BRUSHY CREEK REGIONAL
UTILITY AUTHORITY RAW
WATER PUMP STATION

SP-2020-0228D

VARIANCE REQUEST

SLOPE EXHIBIT

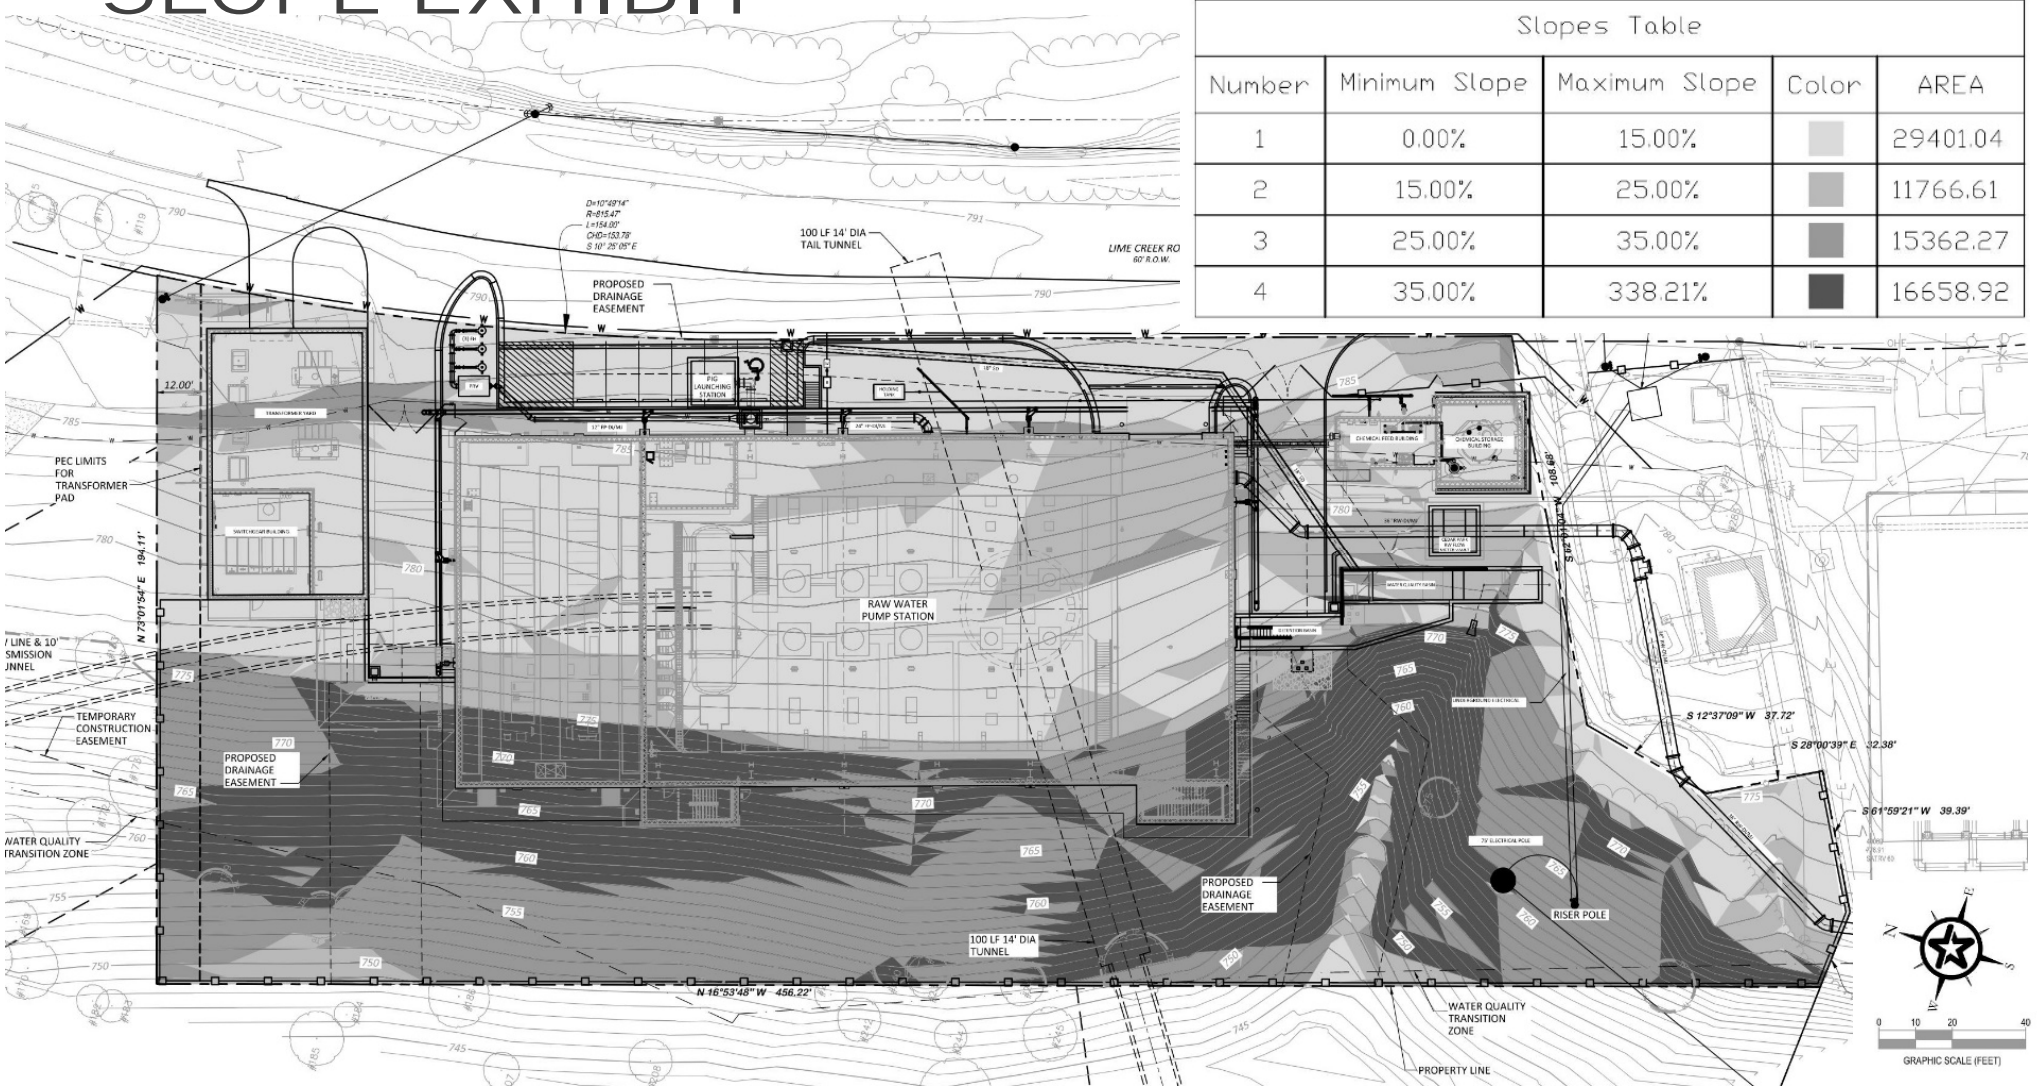
1. Request to vary from LDC 25-8-301 to construct private driveways crossing slopes in excess of 15 percent gradient.
2. Request to vary from LDC 25-8-302(A) to construct a surface parking lot on slopes in excess of 15 percent gradient.
3. Request to vary from LDC 25-8-302(B) to construct a building on slopes in excess of 25 percent gradient, and exceed impervious cover allowance on slopes with a gradient of more than 15 percent.
4. Request to vary from LDC 25-8-342 to allow fill in excess of four feet in the Drinking Water Protection Zone.
5. Request to vary from LDC 25-8-453(D)(1) to allow impervious cover in excess of 20 percent Net Site Area.

- Restoration of disturbed areas within the 40% Natural Area Buffer shall be subject to ECM Appendix A criteria;
- Provide robust temporary and permanent erosion and sedimentation controls downgradient of the proposed development beyond the minimum standard;
- Provide water quality and detention for an area of offsite impervious cover such that the total amount of impervious cover treated is comparable to only having 20 percent impervious cover onsite
- Provide dense screening vegetation in compliance with ECM 2.9.0 for all pervious areas between the building and mechanical equipment and the right-of-way.
